ARCHITECT'S SUPPLEMENTAL INSTRUCTIONS

PROJECT:	The Reserves at South Lake New Apartment Complex Grinnell, IA	Report No.	One (1)
OWNER:	OPG South Lake Partners, LLC Dan Maximuk 234 N. Santa Fe Ave, Suite A Salina, KS 67401	Date	Nov. 14, 2022
CONTRACTOR:	MCP Group 3501 SW Fairlawn Rd. Topeka, KS 66614	Architect's Proj No.	20-3118
		Contract For:	General Construction Mechanical, Electrical

VE Items

S1.2

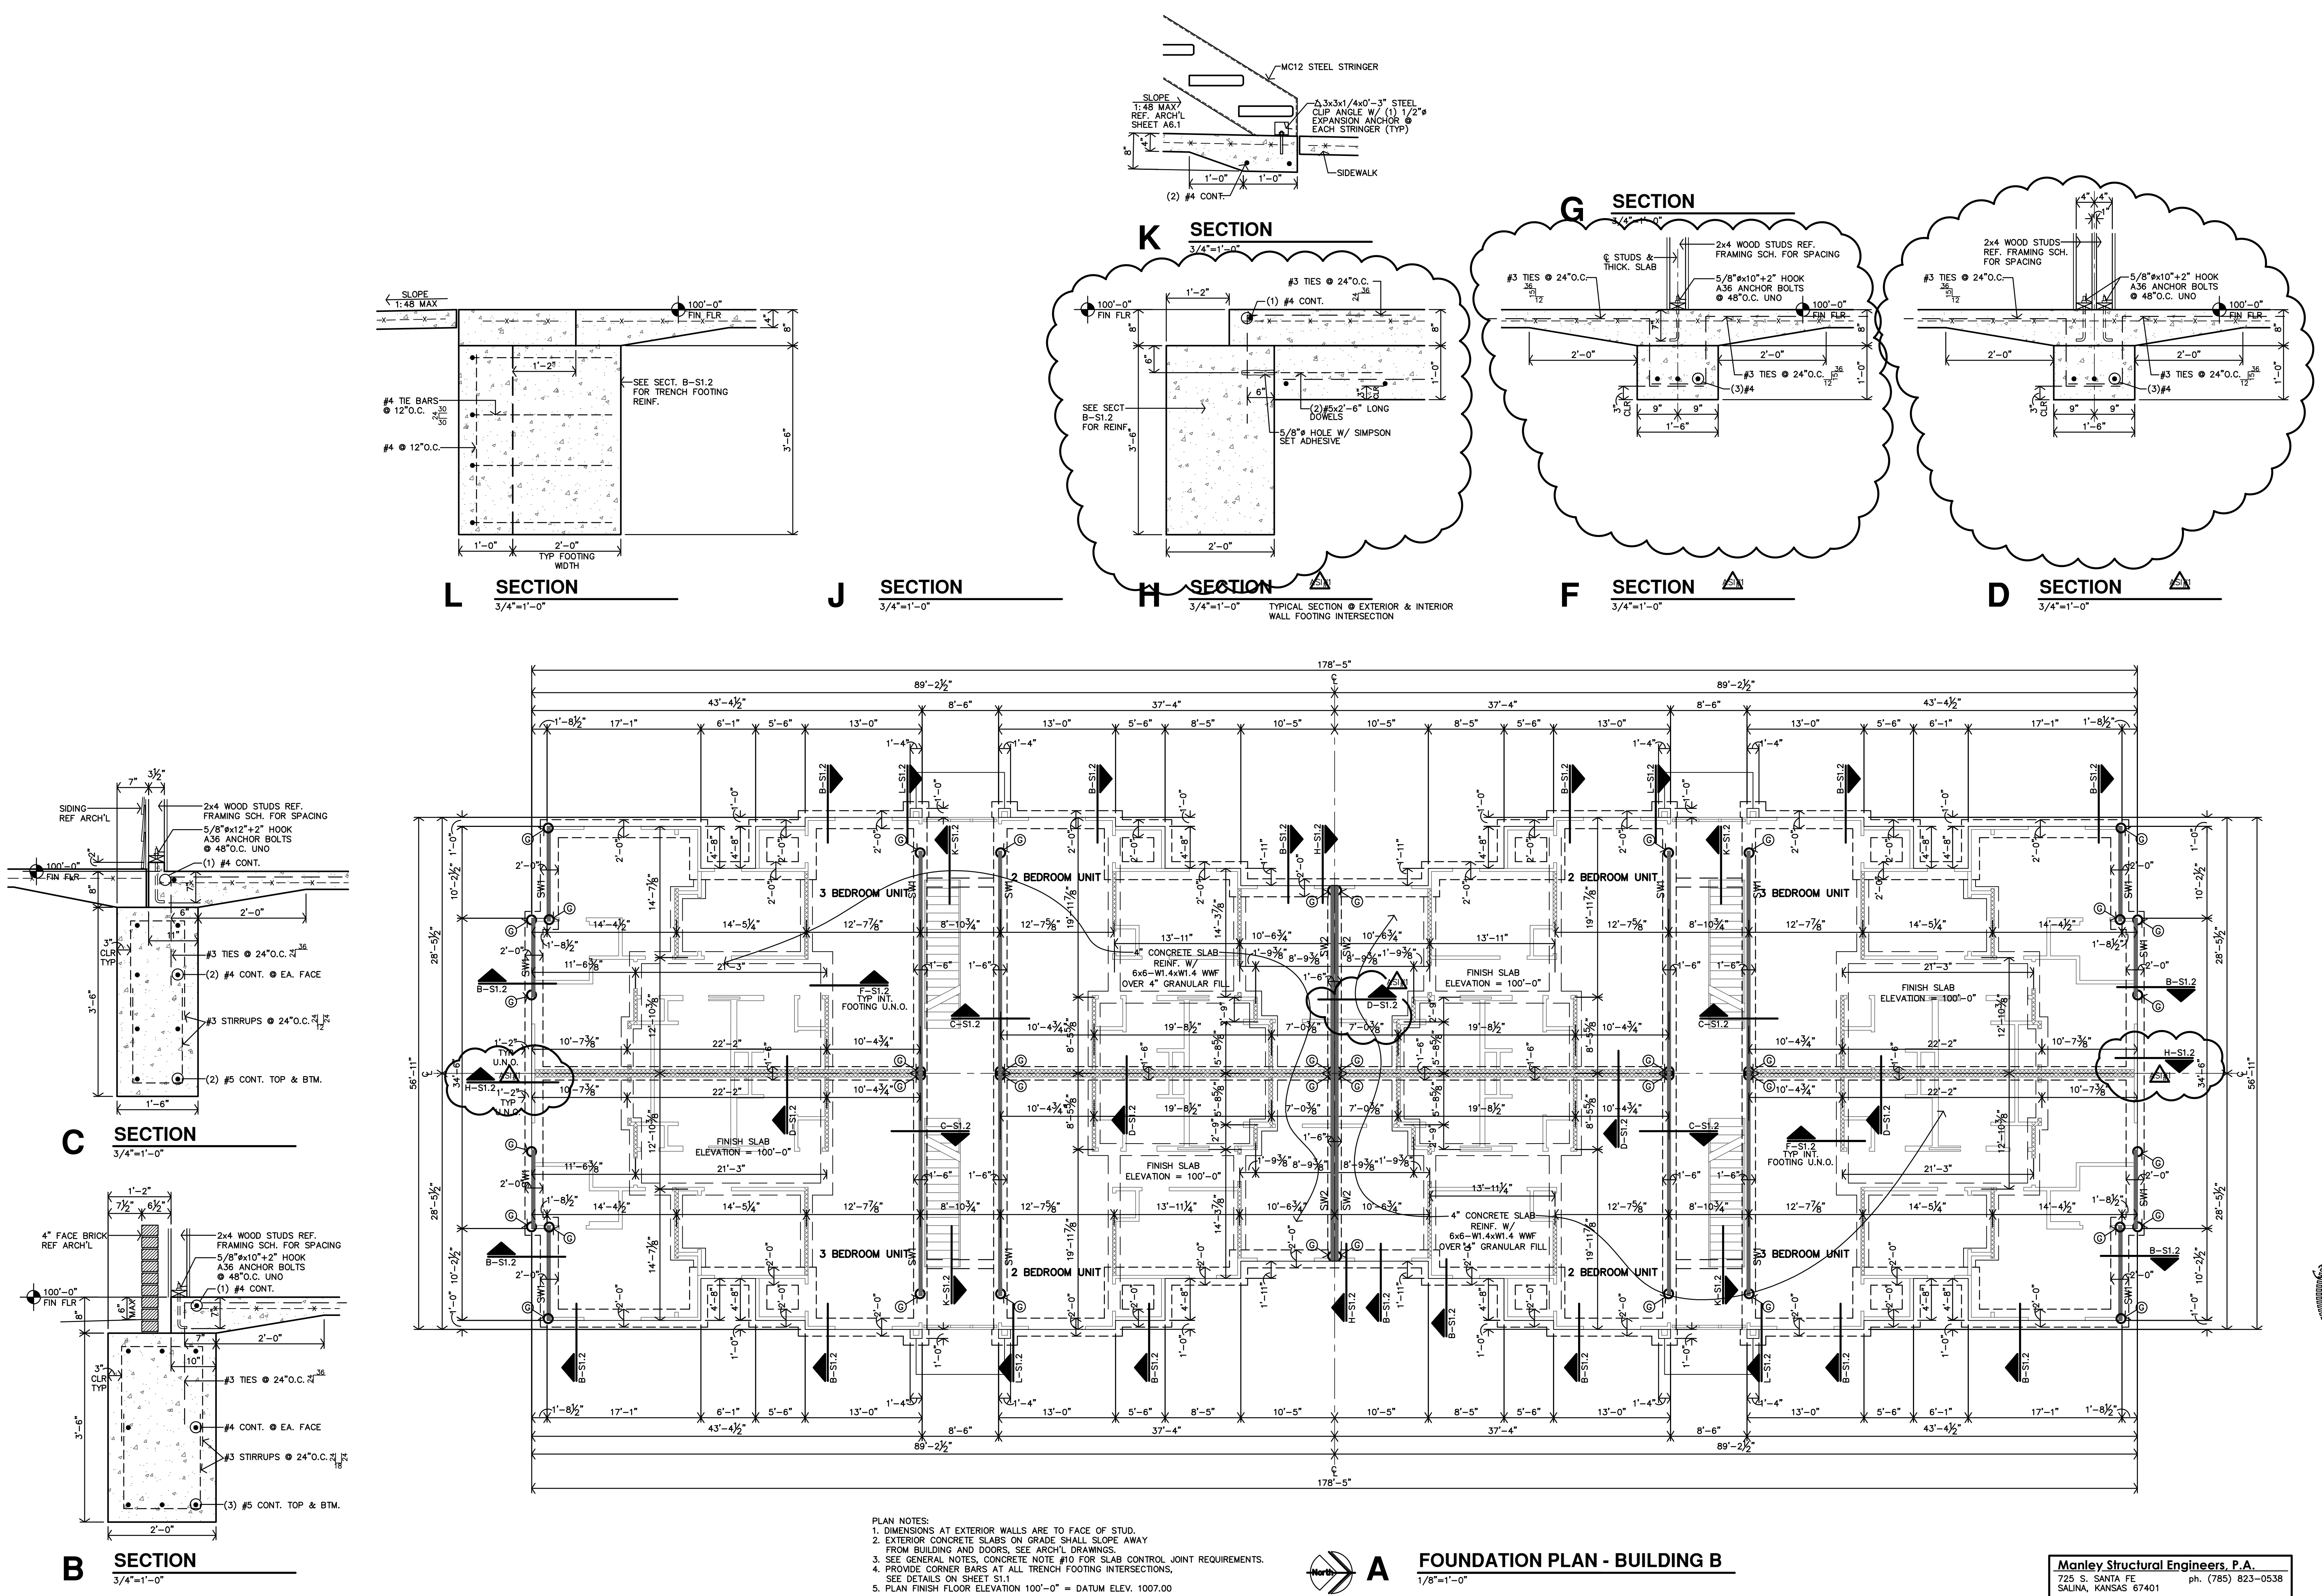
- 1) Change interior slab to 1' thickened slab
 - a. Interior footing revised. Ref. sheets S1.1 & S1.2. Changes to be approved by Energy Consultants.
- 2) Alternate brick Selection
